## **Appendix 4.1: Report for Design Changes for Line 3A Phase 1**

**HO CHI MINH CITY URBAN RAILWAY CONSTRUCTION PROJECT  
LINE 3A PHASE 1 (BEN THANH – MIEN TAY TERMINAL)**

**REPORT FOR DESIGN CHANGES**

**May 2016**

Figure 5.4.1 C4 Location between FS and this Study

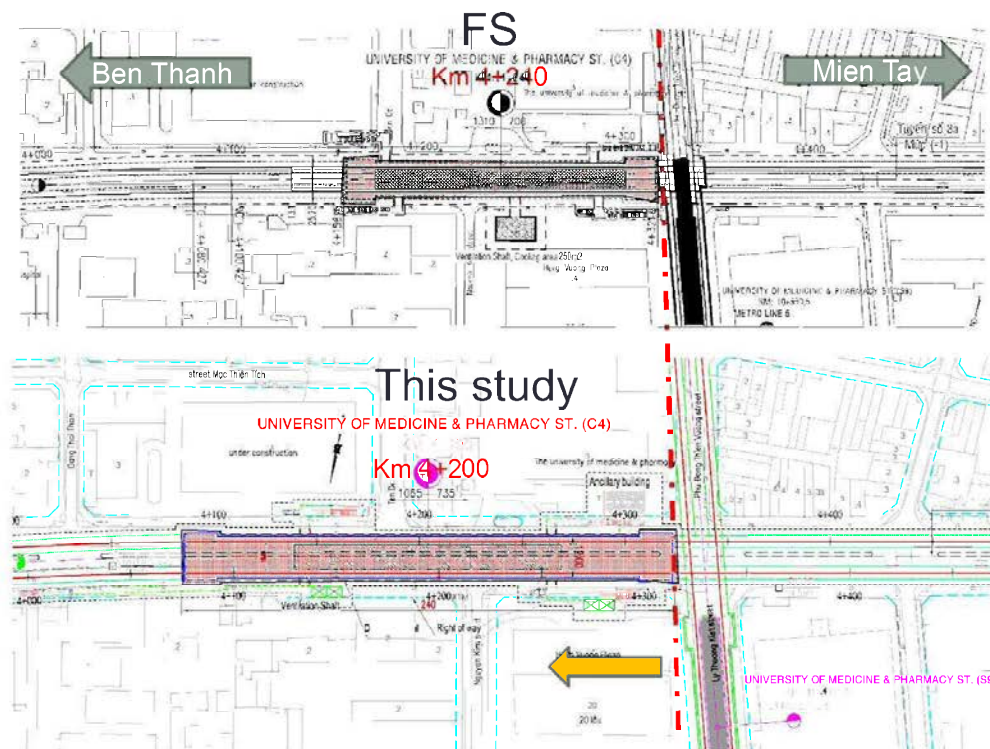
In the same manner with other stations, the station length of C4 needs expansion. Taking into account the Line 5 station at Mien Tay direction, the station length is extended toward the other direction. The centre of the station is revised from Km 4+240 to Km 4+200 as shown in Figure 5.4.1.

Figure 5.5.1 C5 Location between FS and this Study

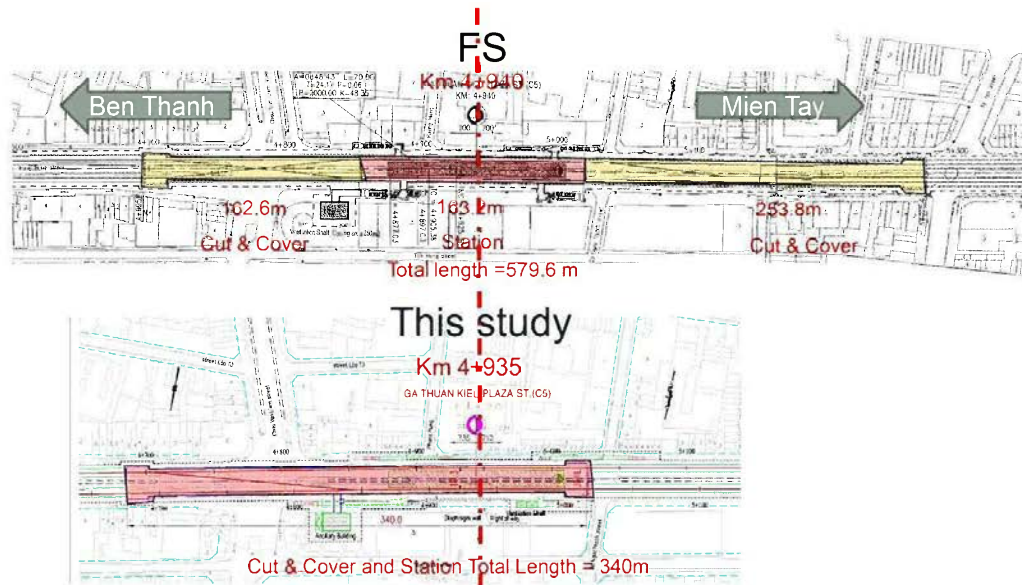
The centre of the station is slightly moved by 5m due to alignment change. Also, station and cut & cover lengths for crossing trains are revised as indicated in Figure 5.5.1.

Figure 5.5.2 Track Layout at C5 between FS and this Study

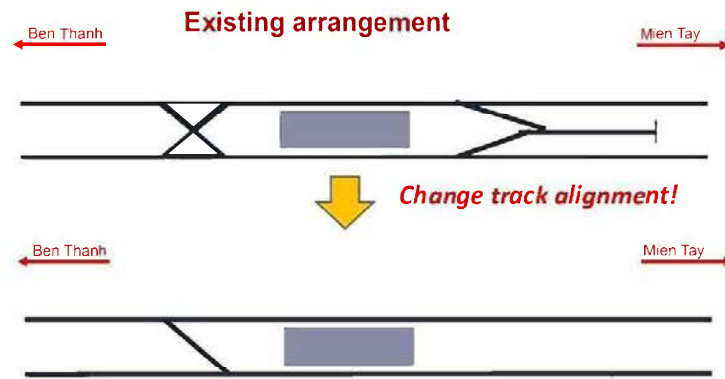
The reason for the above revision is the change in track layout of C5 as shown in Figure 5.5.2. Such change in the track layout will reduce construction and maintenance cost.

After review of the latest traffic forecast and train operation, the JST concluded one turnout at C5 is sufficient to manage traffic. The remained turnout at Ben Thanh direction will be used for emergency cases such as accident. Scissors crossing seems over investment as this exceptional case occurs only few times a year according to Tokyo Metro in Japan.

Given the frequency of incident and maintenance cost, turnout is selected instead of scissors crossing.

Figure 5.6.1 C6 Location between FS and this Study

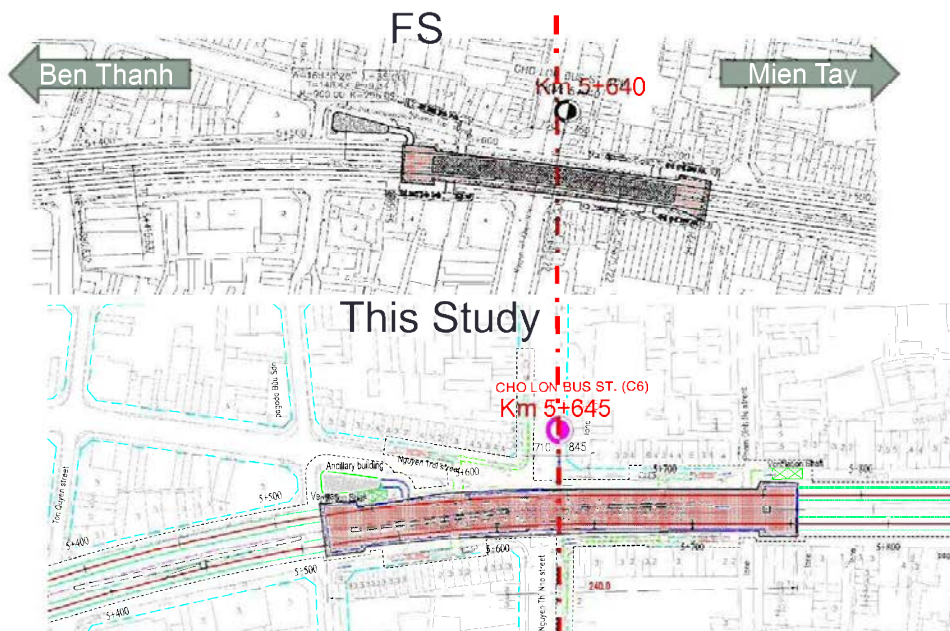
The centre of the station is slightly moved by 5m from the FS due to the alignment change as shown in Figure 5.6.1.

Figure 5.7.1 C8 Location between FS and this Study

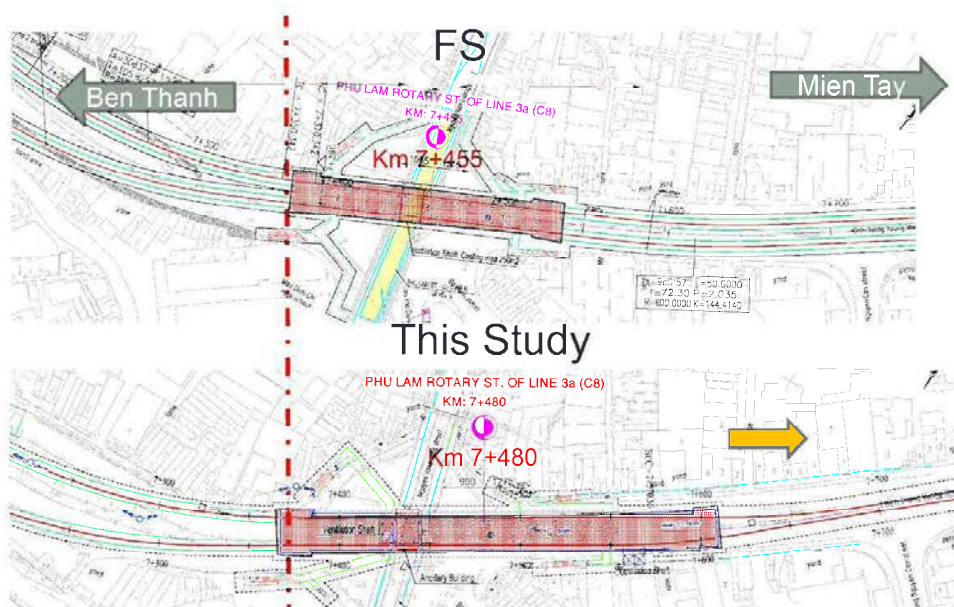
In the same manner with other stations, the station length of C8 needs expansion. Due to a curve at Ben Thanh direction, station length is extended to the other direction. The centre of the station is revised from Km 7+455 to Km 7+480 as shown in Figure 5.7.1.

Figure 5.8.1 Track Layout at C10 between FS and this Study

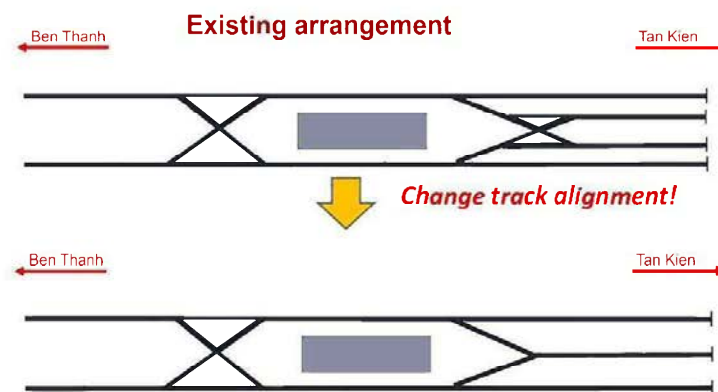
In addition, the track layout of C10 is revised considering train operation because of the following reasons (see Figure 5.8.1).

Firstly, the purpose of the revision is to reduce construction and maintenance cost.

Secondly, overnight stabling of trains at C10 is not required after Phase 2 opening.

Hence, only one additional side track is required between the two main tracks for a turn over and receiving failure trains.

Figure 6.1.1 C7 Location on FS

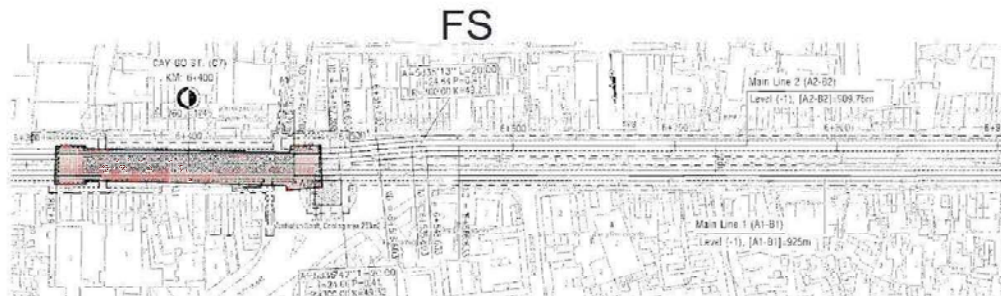
The centre of C7 was designed at Km 6+400 by the FS as shown in Figure 6.1.1. However, it requires redesign as Cay Go flyover was constructed on the station alignment after the FS as indicated in Figure 6.1.2.

Figure 6.2.1 Five Options for a New Design of C7

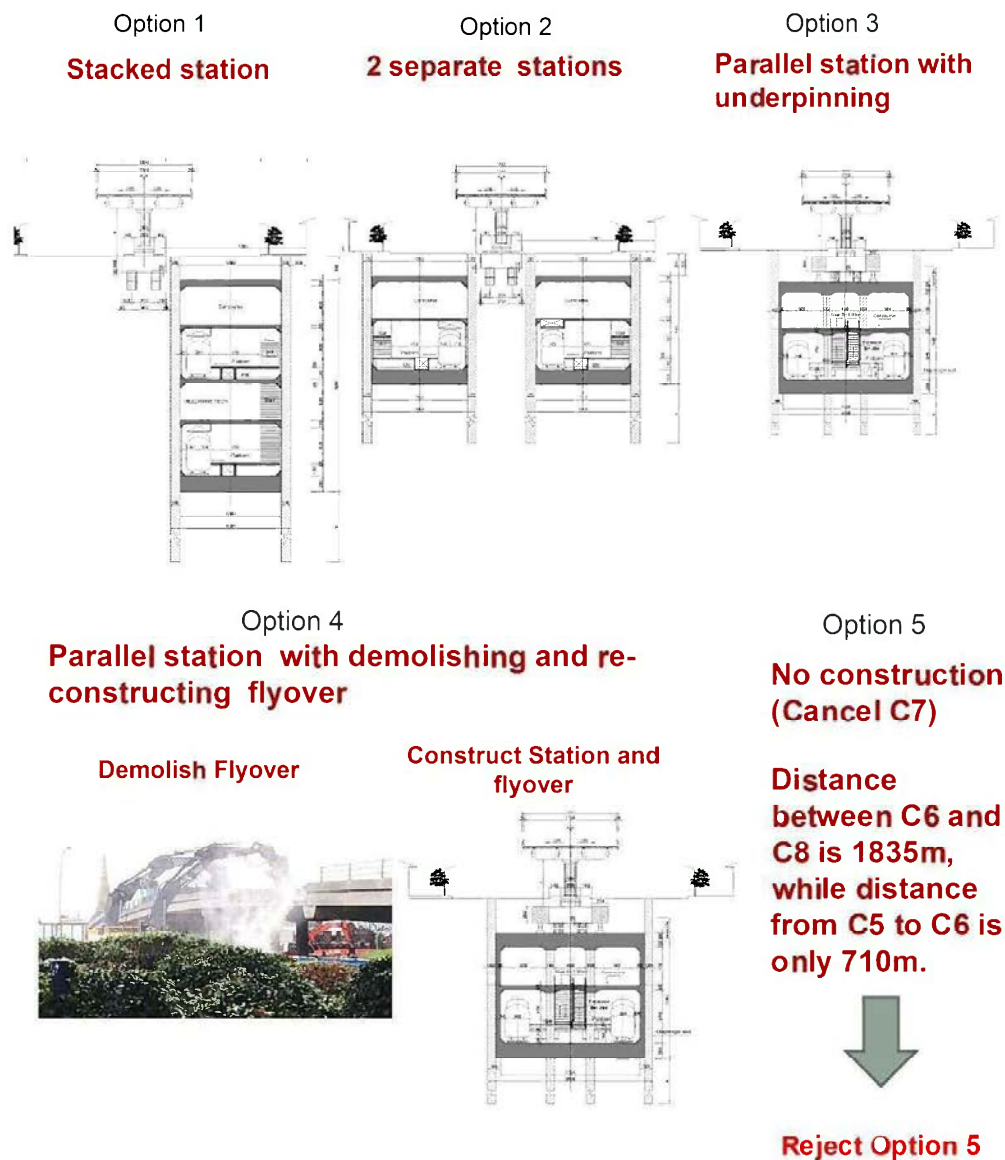
As shown in Figure 6.2.1 five options of C7 designs are considered i.e. Option 1: stacked station, Option 2: two separate stations, Option 3: parallel station with underpinning, Option 4: parallel station with demolishing and re-constructing flyover and Option 5: no construction (cancel C7).

Stacked station requires stacked tunnel alignment, the deepest section and the longest station length compared to other options.

Two separate stations require two separate station facilities beside Cay Go flyover. This option brings inconvenience to passengers, e.g. separate platforms require long distance of walking.

Parallel station with underpinning requires the most difficult construction method. The station needs to be constructed underneath Cay Go flyover using temporary jacks and piles plus monitoring thereof without making any traffic disruption on the flyover. In addition, thicker concrete slabs and walls are necessary compared to normal stations (C1 to C6 and C8), since C7 structure must receive loads from Cay Go flyover.

Parallel station with demolishing and re-constructing flyover is the method to construct the station after demolishing Cay Go flyover and later rebuild the flyover. Although the station structure requires thicker concrete slabs and walls in the same manner with the Option 3, the construction work is much easier than that of underpinning method.

No construction option, i.e. cancellation of C7, will make distances between stations unequal. As this causes inconvenience to users, this option is no longer considered.

**Figure 6.4.1 C7 Location by Option 4**

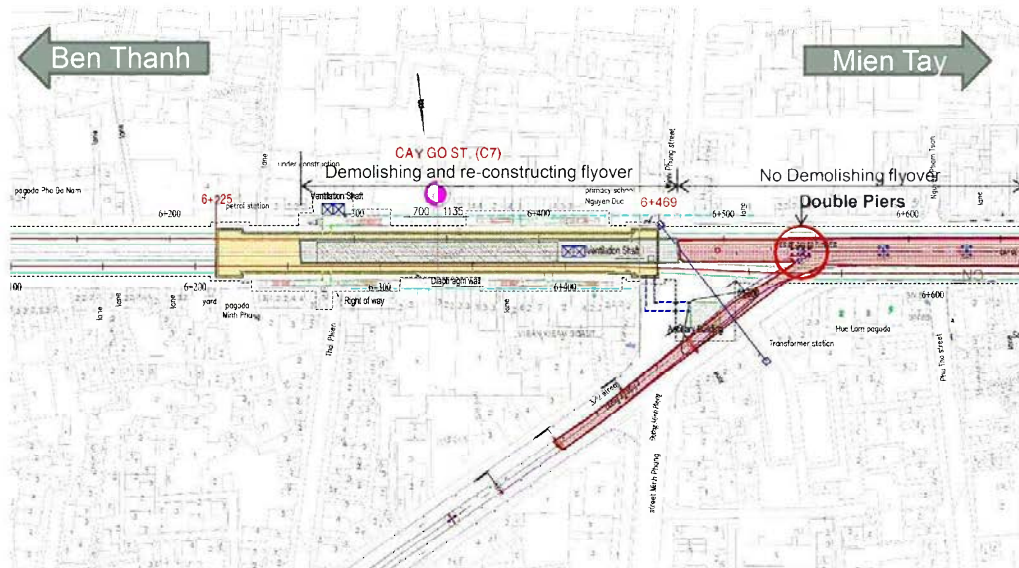
The station location should consider the actual site conditions and reconstruction of the flyover. The centre of the station was revised from Km 6 + 640 to Km 6+345 with the following reasons.

Firstly, a busy intersection should be kept functional during the construction because Cay Go flyover will be demolished. End of diaphragm wall of the station should not interfere with traffic flow in the intersection.

Secondly, removing and re-constructing double piers of the flyover is difficult work. Therefore, the JST propose not to remove them.

With the above considerations, about 230m of flyover will be demolished and re-constructed, while remaining part will be kept un-demolished for the traffic from 3/2 street during the construction.
